Inspection Report for North Sturbridge Road Solar Facility

NPDES ID No.: MAR10031G

Inspection Date: 10/29/2021

**FIGURE 1:
SWPPP
INSPECTION
SKETCH
10/29/2021**

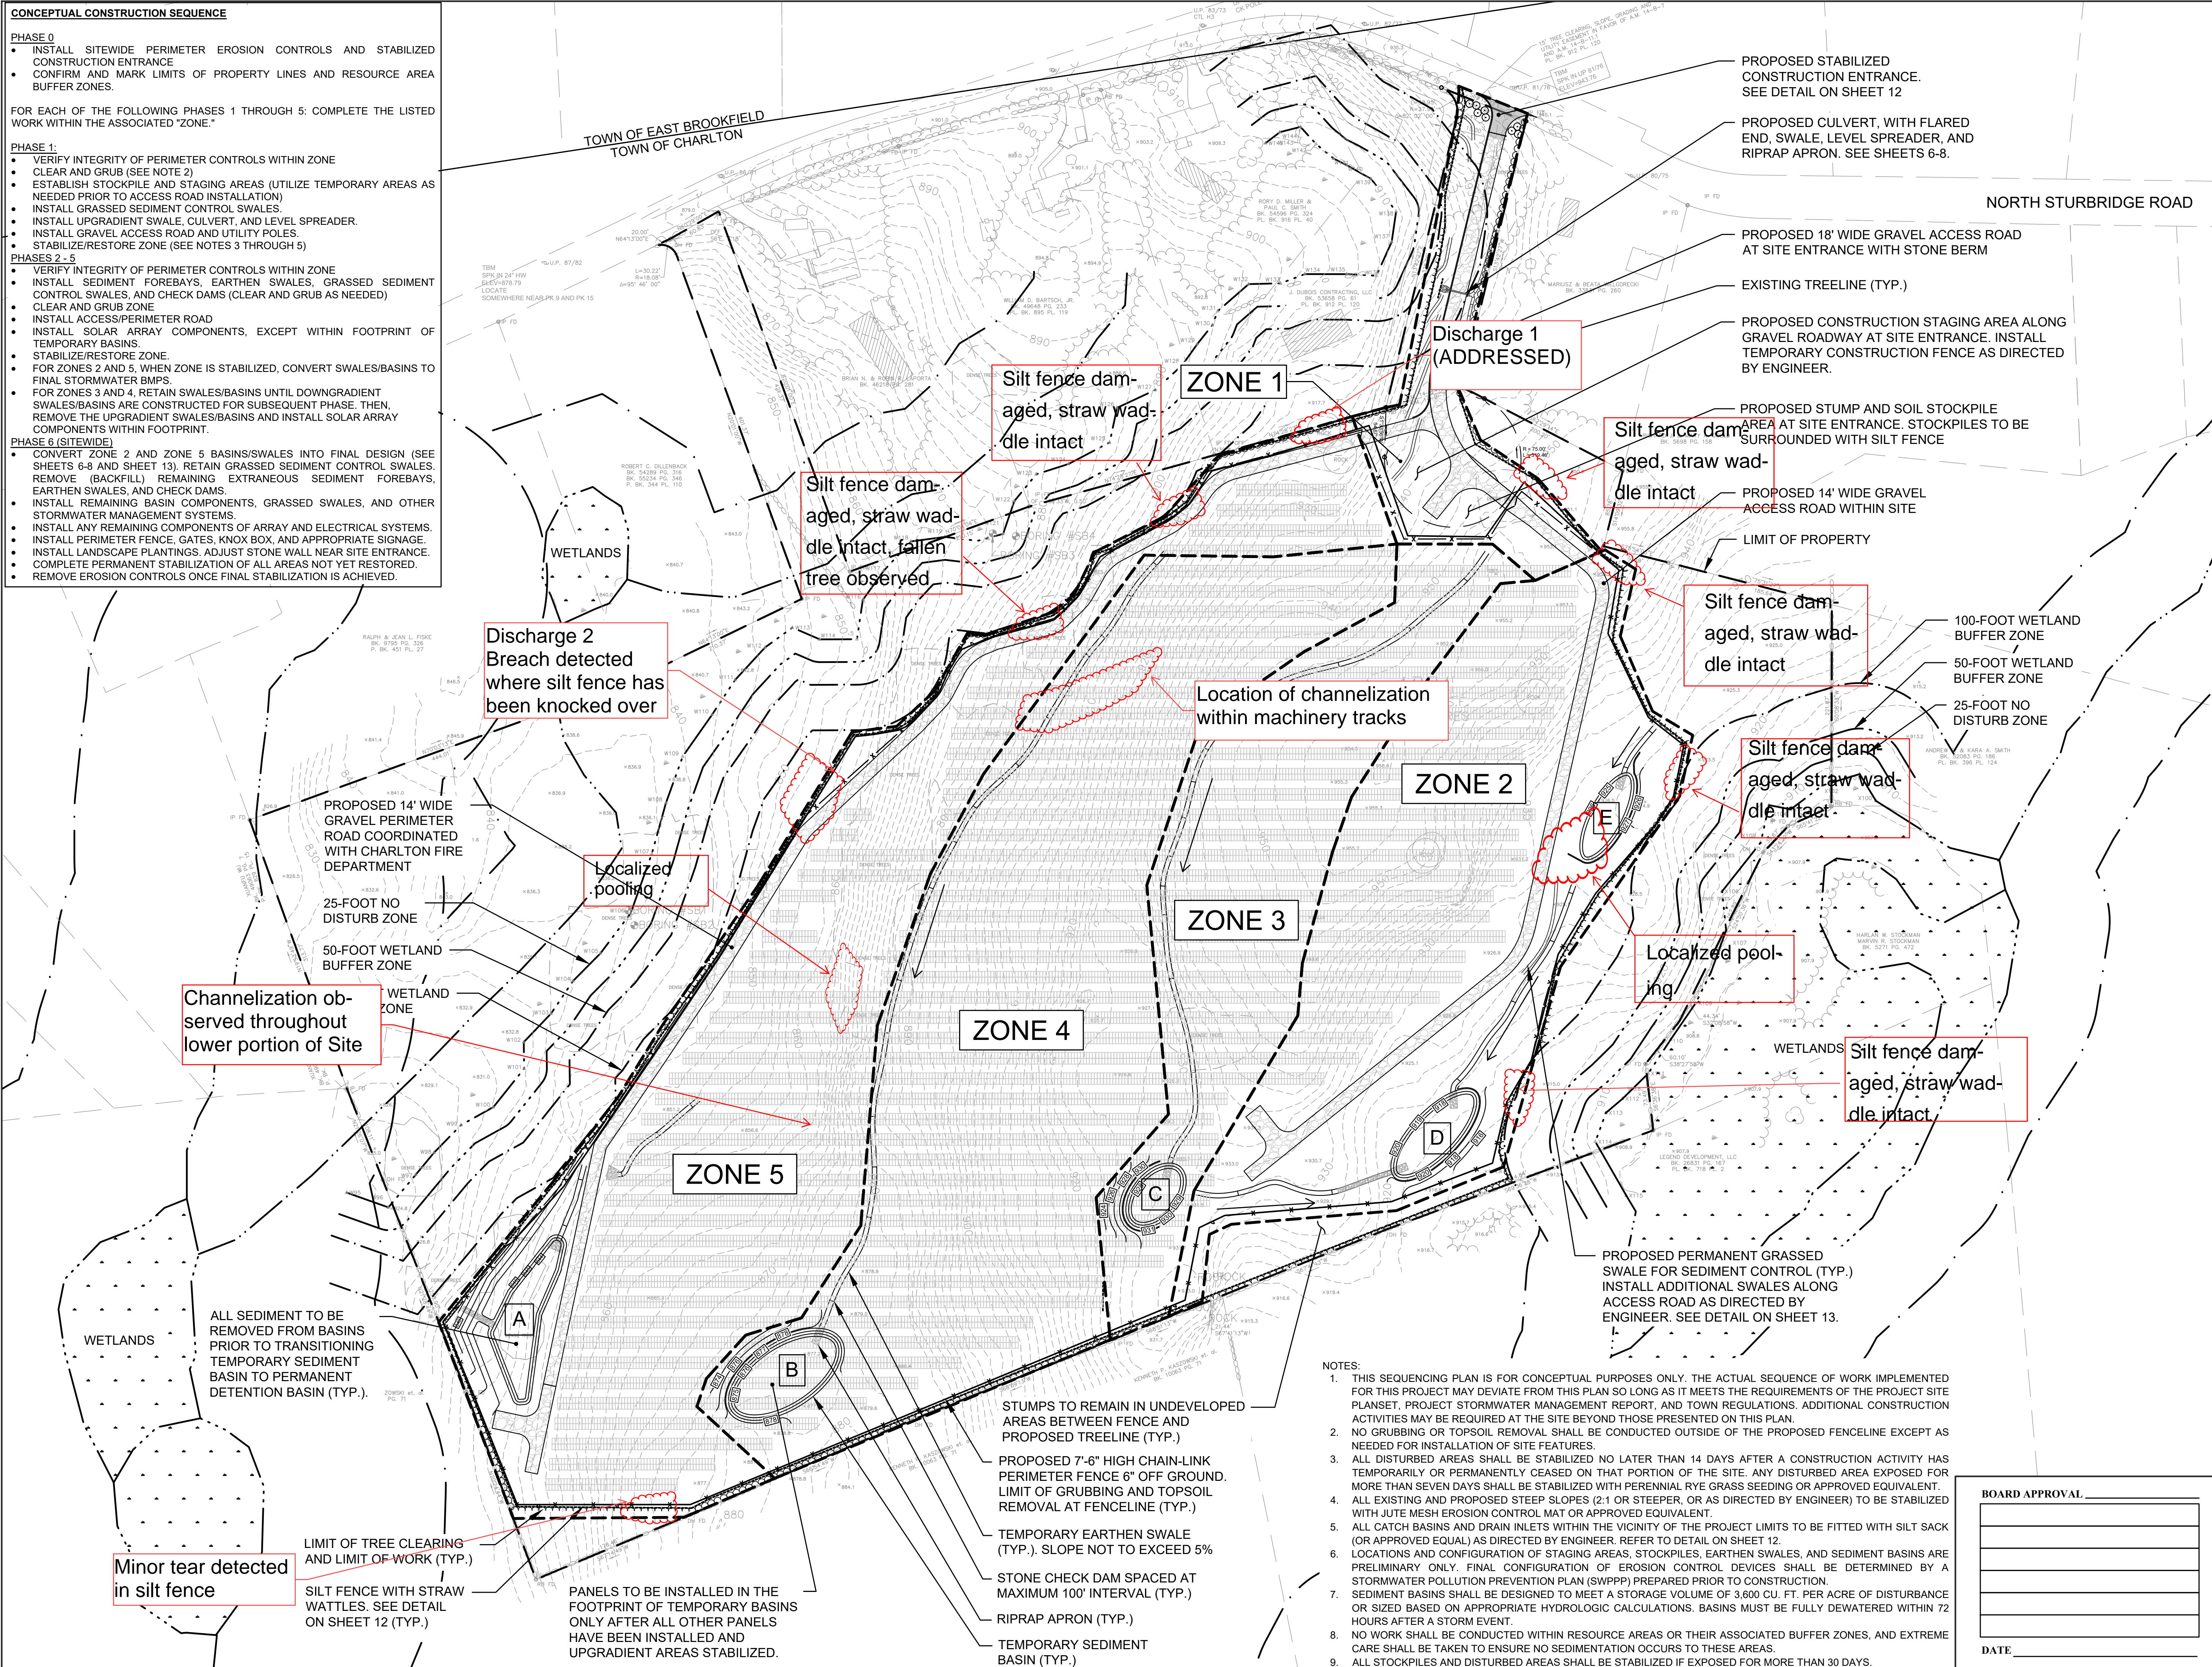
Minor tear detected in silt fence

Channelization observed throughout lower portion of Site

Localized pooling

Location of channelization within machinery tracks

Silt fence damaged, straw wattle intact, fallen tree observed

Silt fence damaged, straw wattle intact

Silt fence damaged, straw wattle intact

Silt fence damaged, straw wattle intact

Silt fence damaged, straw wattle intact

Silt fence damaged, straw wattle intact

Discharge 1 (ADDRESSSED)

Discharge 2 Breach detected where silt fence has been knocked over
